PROJECT NAME: ORANGE BLOSSOM REPLAT #1

PROJECT NUMBER: 2025050013

APPLICATION: PRELIMINARY PLAT #32811

SITE PLAN

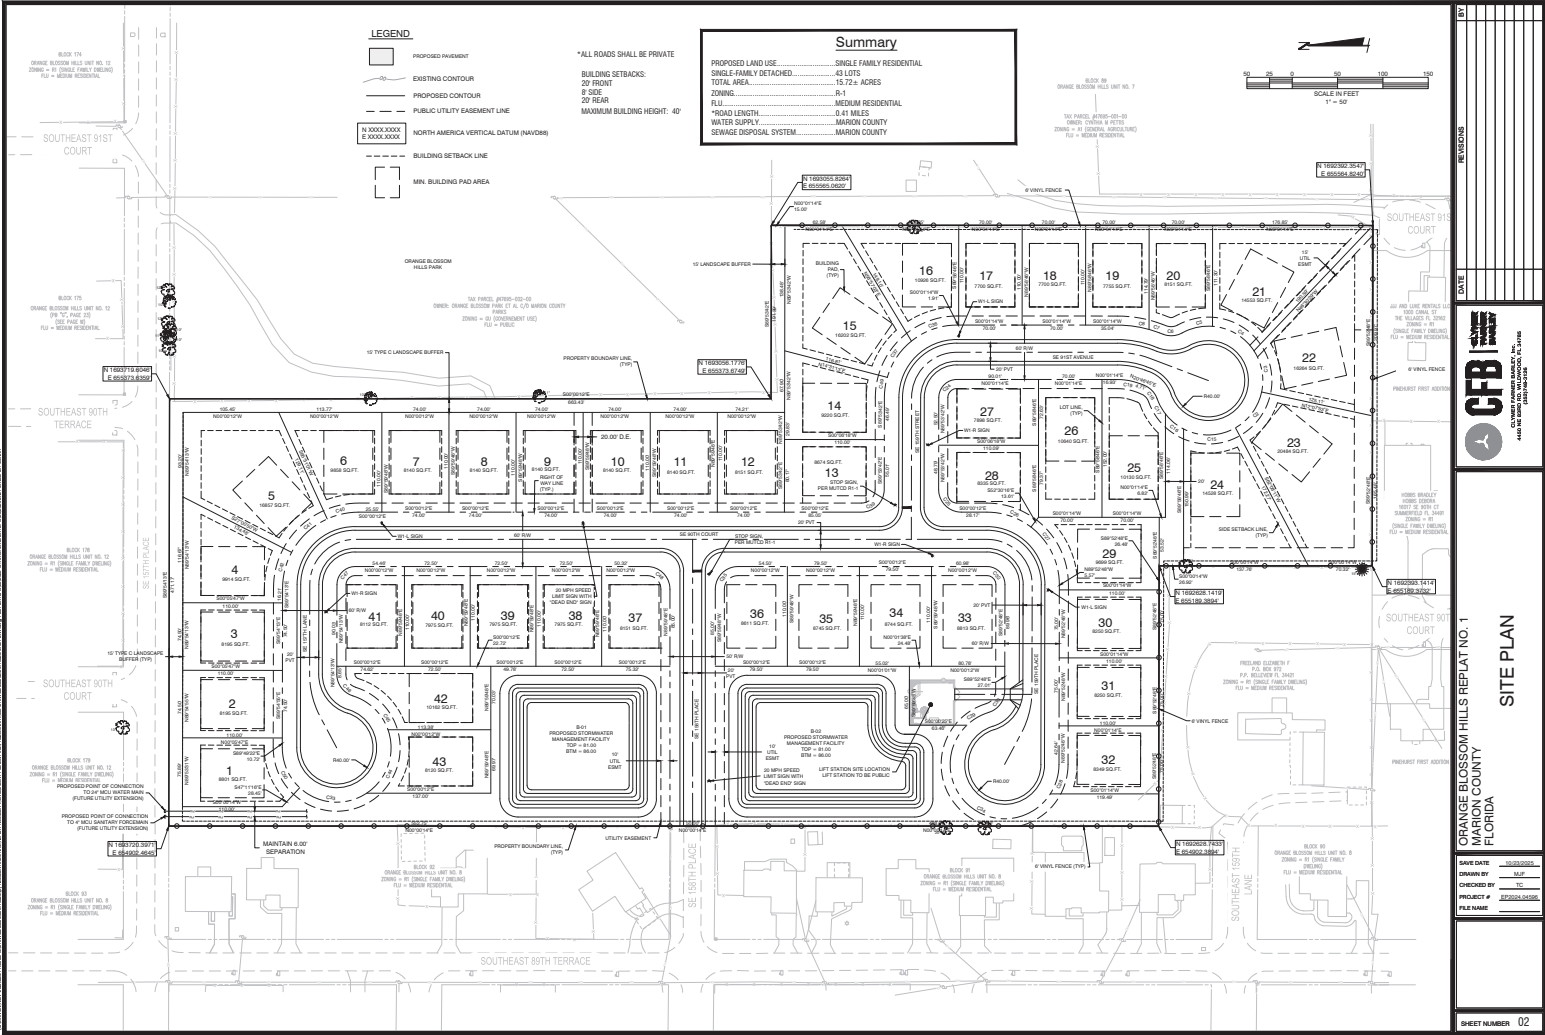
Please Note: Proposed utility connections shown on the plan submittal dated 10/23/2025 are not approved by Marion County Utilities and will not be approved in the future. Please coordinate with MCU staff prior to submitting improvement plans that include utility connections.

LANDSCAPE AREA DIAGRAM
NOT TO SCALE

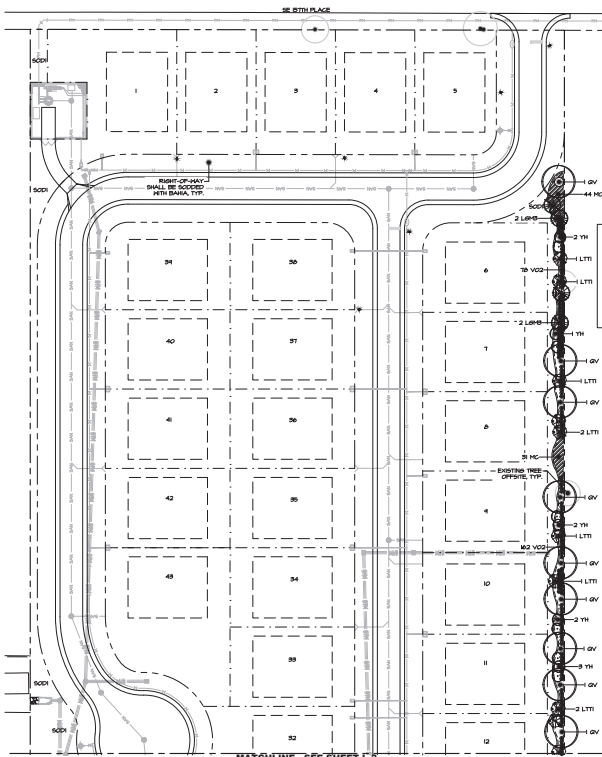
REMARKS: Who owns fence? How will it be maintained and or repaired? Will HOA enforce fence maintenance and ensure uniformity?
